Narooma Wharf Upgrade

Submissions report

Transport for NSW | October 2022

Revised proposal

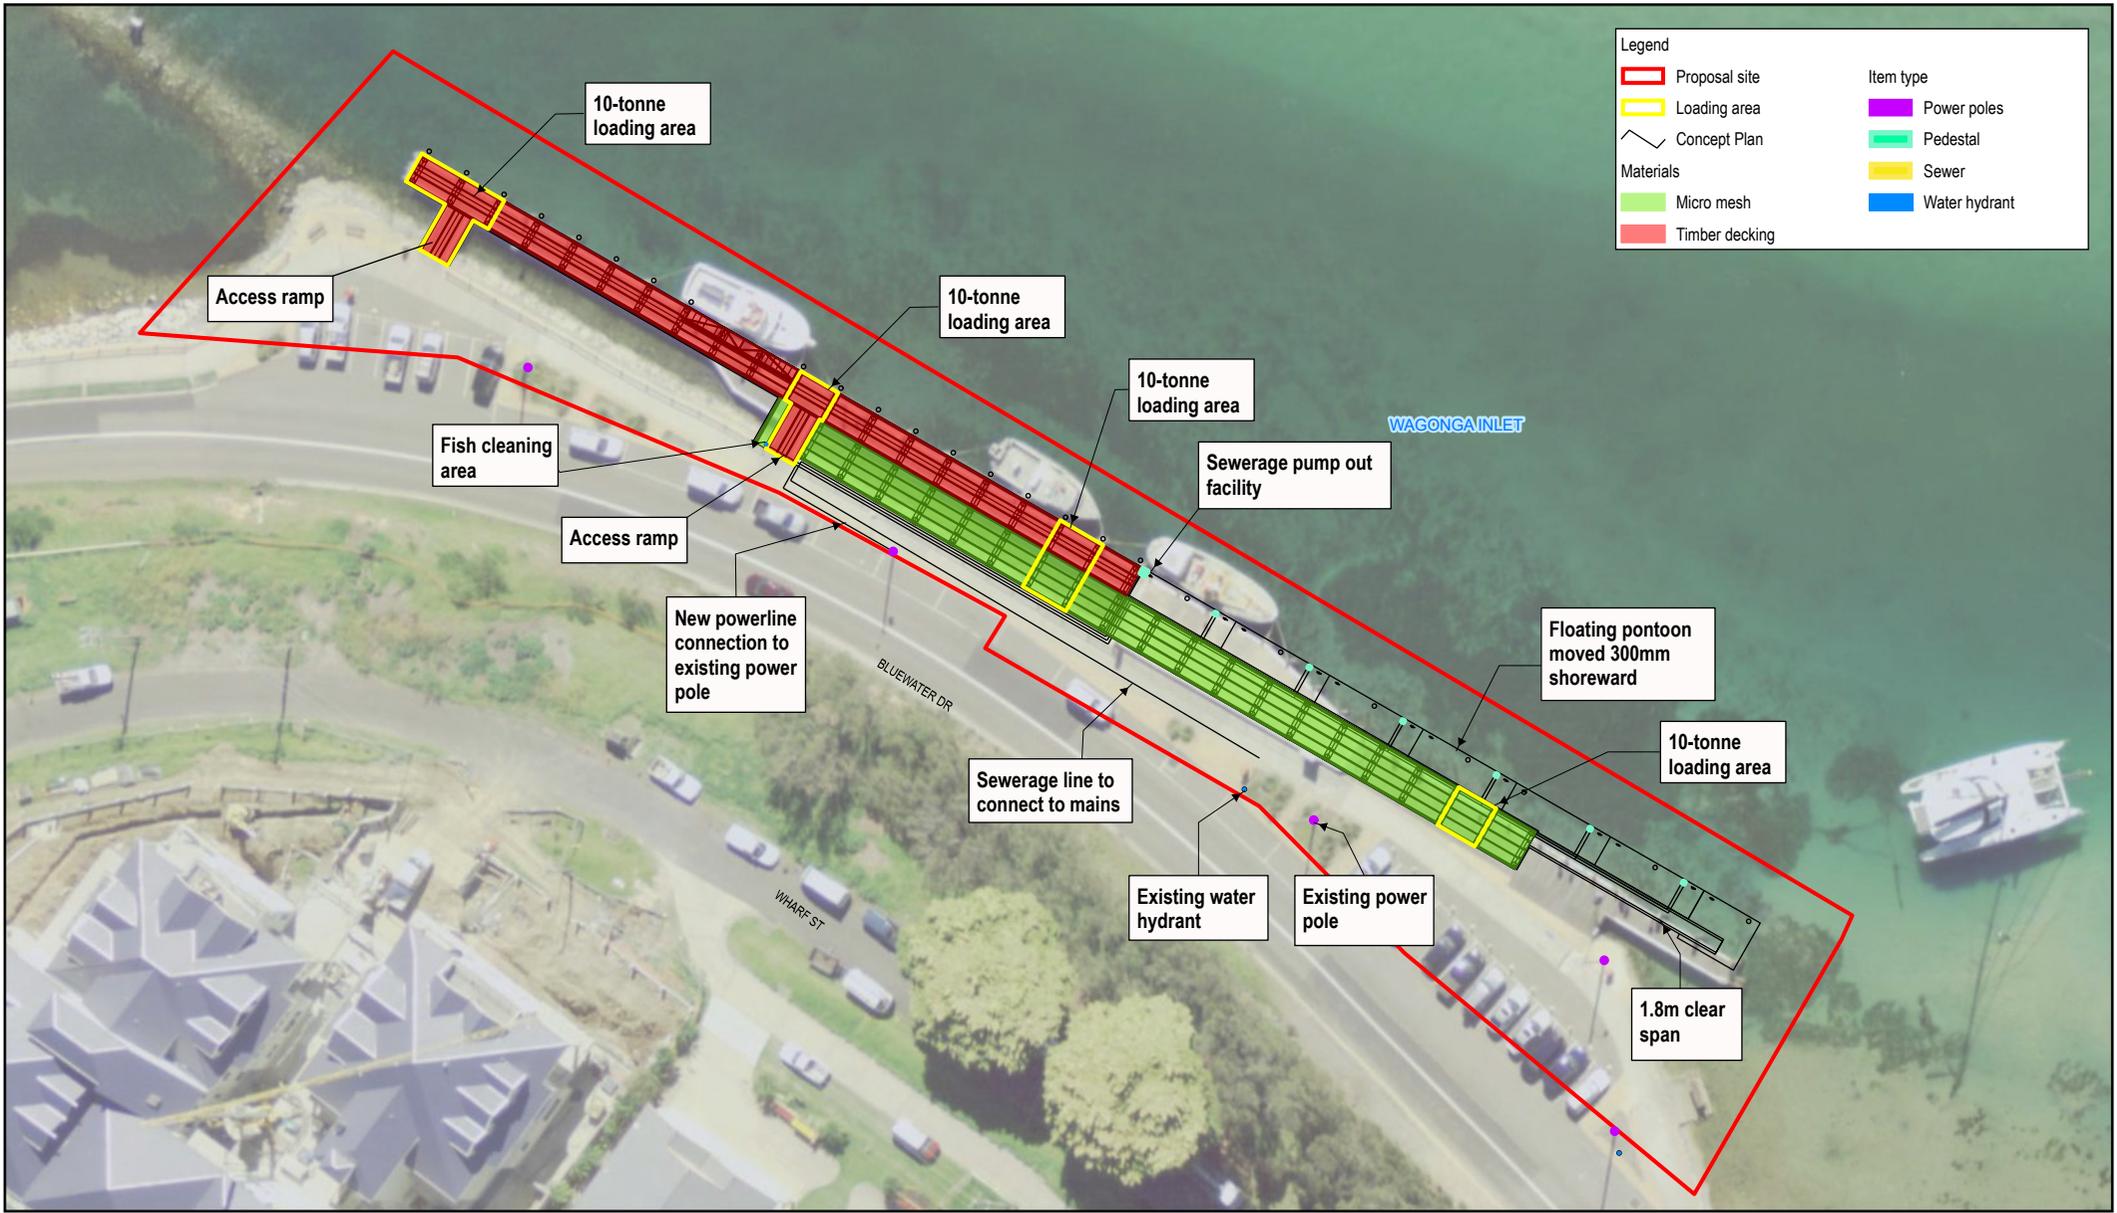
During the public display of the REF, minor modifications to the concept design of the proposal have occurred. These include:

- removal of the lower level landing
- provision of an additional loading platform to provide a total of four loading platforms for 10-tonne vehicles along the wharf
- adjustment of the floating pontoon shoreward
- increase of the gangway clear width to 1.8 metres
- lowering of powered lighting on the floating pontoon.

These modifications are minor and do not change the extent of the proposal site, nor do they introduce new elements that have not already been assessed in the REF. The environmental assessment presented in the REF remains valid and no additional assessment is considered necessary. Following approval of the REF, elements of the proposal would continue to be further refined during the detailed design phase.

In response to the outcomes of the community consultation, the proposed design has been amended to remove the lower level landing, and instead the whole of the main wharf would be one level. This design change would benefit more commercial operators by providing more space along the main wharf to berth, load and unload vessels. It would also provide more space for the boarding of passengers.

The original proposal in the REF included the provision of two loading platforms on the main wharf to allow vehicles to access the wharf for the refuelling, loading and unloading of vessels. Following community consultation, two additional loading platforms have been included into the revised design for the refuelling of smaller boats on the eastern side of the wharf and for National Park and Wildlife Services towards the middle of the wharf.

The original proposal in the REF included the installation of a floating pontoon on the eastern side of the wharf, connected to the shore-side platform via a gangway. Following consultation with DPI Fisheries, the floating pontoon has been moved 300mm closer to the shoreline to reduce shading on the adjacent seagrass populations.
